## Addendum 5 Solicitation 26-99362 Storm Damage Civil Sites Repairs

This addendum serves to notify all bidders of the following changes to the solicitation documents:

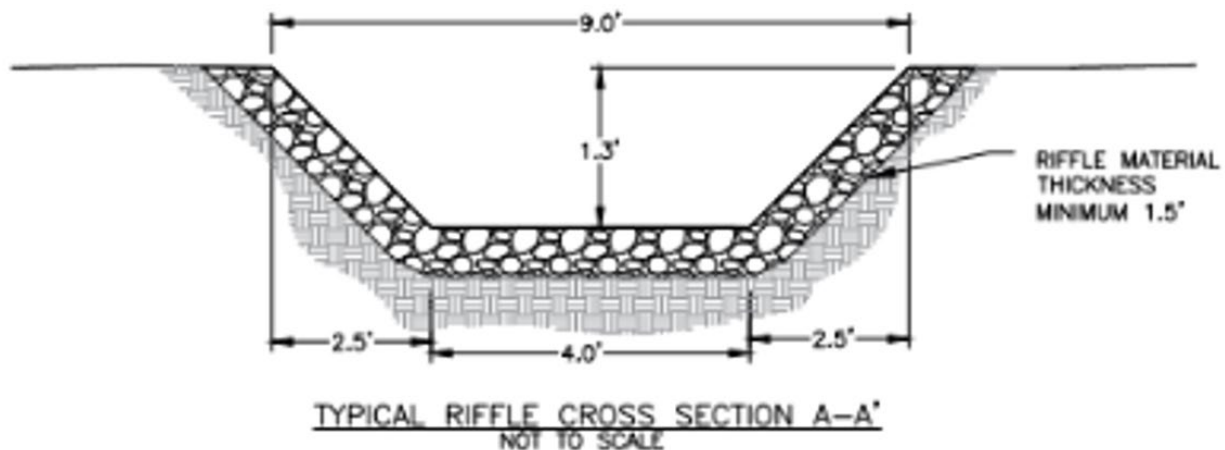
- Fence removal and relocation will be incidental to trail relocation.
- Debris removal from Trib.7 to be marked in the field by owner prior to contractor removal. Focus is on woody debris, may require two site visits. Initial site visit to remove material that is visible on surface. Second visit after multiple rain events to uncover woody debris buried under sediment. Removal per the typical section detail below.

**PLAN / SECTIONS**  
sheet title  
sheet number  
**S1**

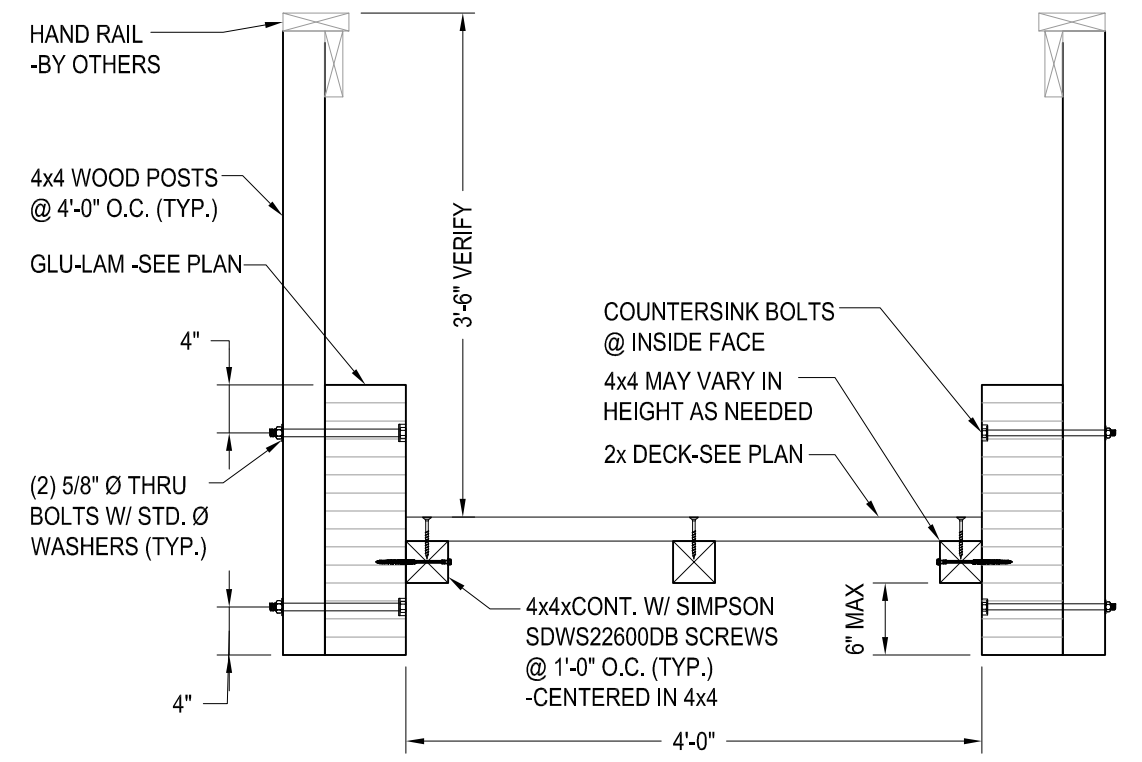
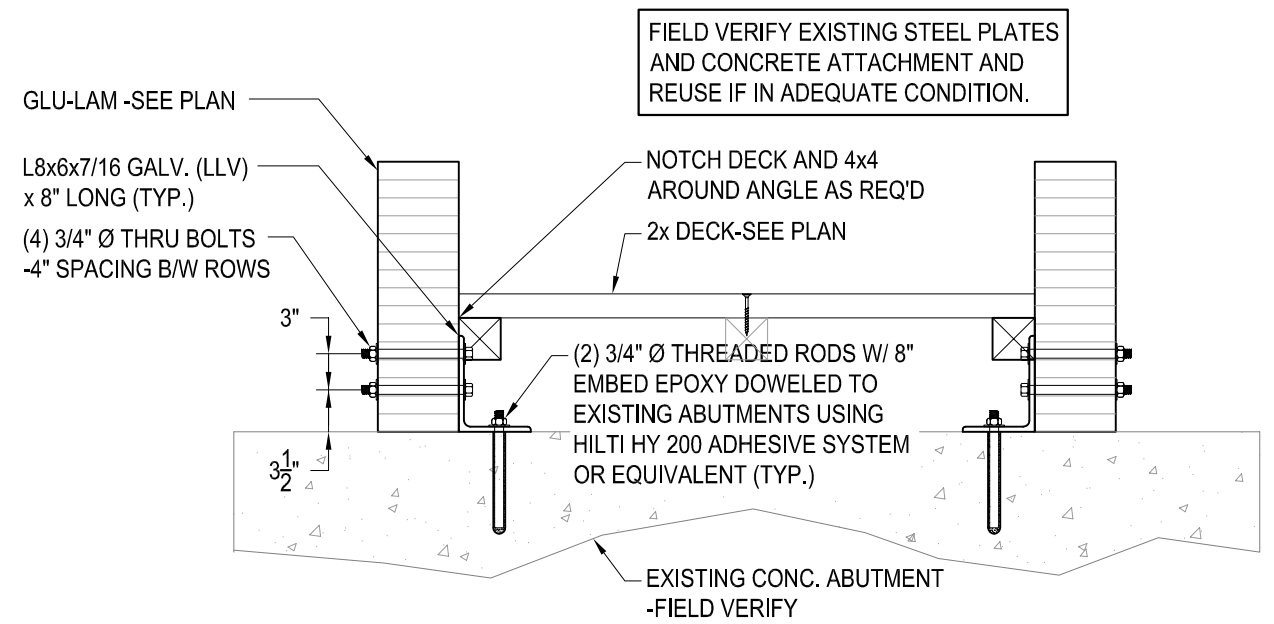
- Would a steel bridge constructed with I-beams beneath the deck, along with a timber deck and railing installed on the proposed concrete footings, be acceptable for the bridge replacement? All required loading and design criteria will be met. Additionally, would this approach be acceptable as a replacement for the proposed glulam approaches, allowing the entire bridge structure to utilize a single, uniform design system.
  - No, bid as is described.

- See original design detail for pricing of Alt bid.
- Contractor to remove existing concrete abutments.
- No tree removal or damage is permitted, contractor must avoid damage to the adjacent old growth white Pines.
